Well Name: O H RANDEL	Well Location: T26N / R11W / SEC 9 / NENE / 36.506993 / -108.00372	County or Parish/State: SAN JUAN / NM
Well Number: 13	Type of Well: OTHER	Allottee or Tribe Name:
Lease Number: NMNM03153	Unit or CA Name:	Unit or CA Number:
US Well Number: 3004532961	Operator: HILCORP ENERGY COMPANY

Notice of Intent

O H RANDEL 13

P&A NOI

O H RANDEL 13 - PROPOSED WELLBORE SCHEMATIC

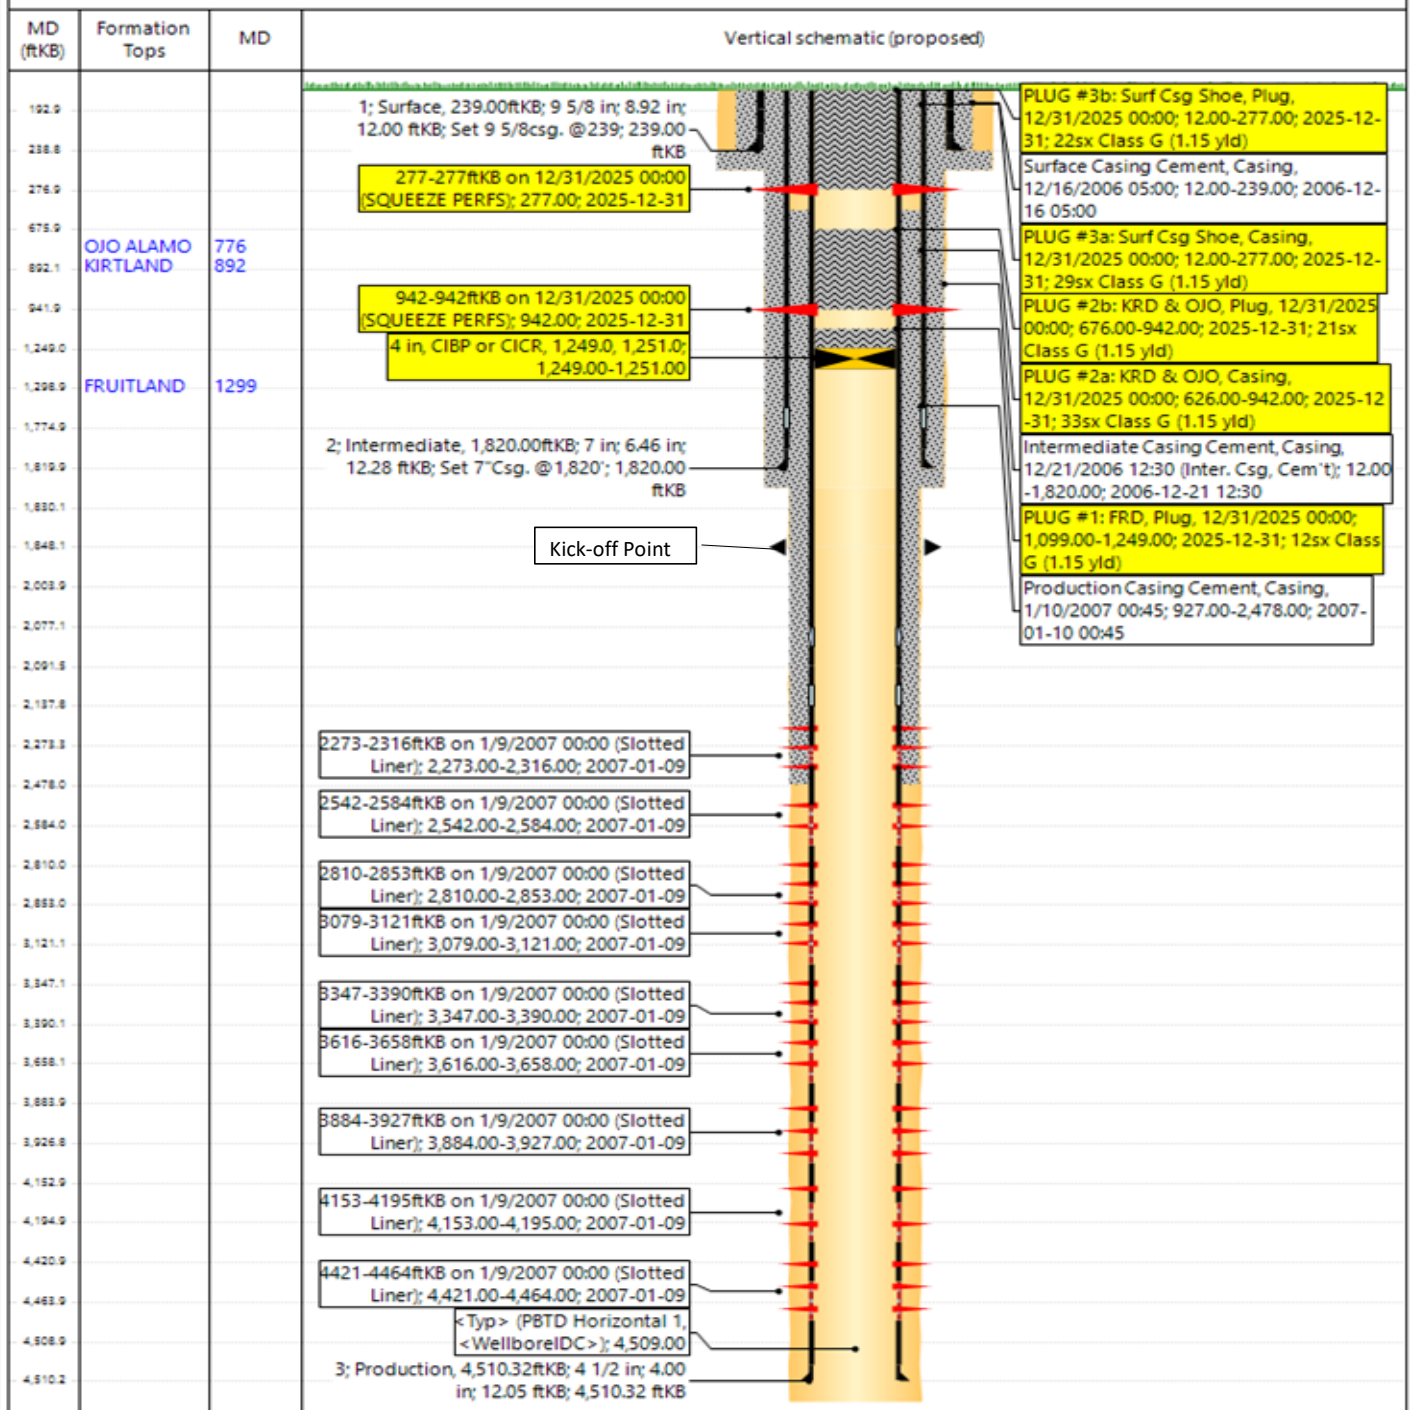
Operator selected formation tops are appropriate for the area. No changes to the procedure.

Created By	Condition	Condition Date
loren.diede	Notify the OCD inspection supervisor via email 24 hours prior to beginning Plug & Abandon (P&A) operations.	10/28/2025
loren.diede	NMOCD has determined that the Fruitland formation top is at 1280' TVD (approx 1300' MD). NMOCD requires that the formation top be covered 50' below the formation top to 50' above the formation top TVD, + excess. NMOCD will require that the CIBP be set at 1330' TVD (1359 MD). This is approximately 25 deg Inclination, well within the ability to set a CIBP.	10/28/2025
loren.diede	Submit photo and GPS coordinates of the P&A marker with the final reports. The API# on the marker must be clearly legible.	10/28/2025

1. Plugging operations authorized are subject to the attached "General Requirements for Permanent Abandonment of Wells on Federal and Indian Lease."
2. The following modifications to your plugging program are to be made:
 - a. No changes to the procedure.
3. **Notification:** Farmington Office is to be notified at least 24 hours before the plugging operations commence at (505) 564 7750.

You are also required to place cement excesses per 4.2 and 4.4 of the attached General Requirements.
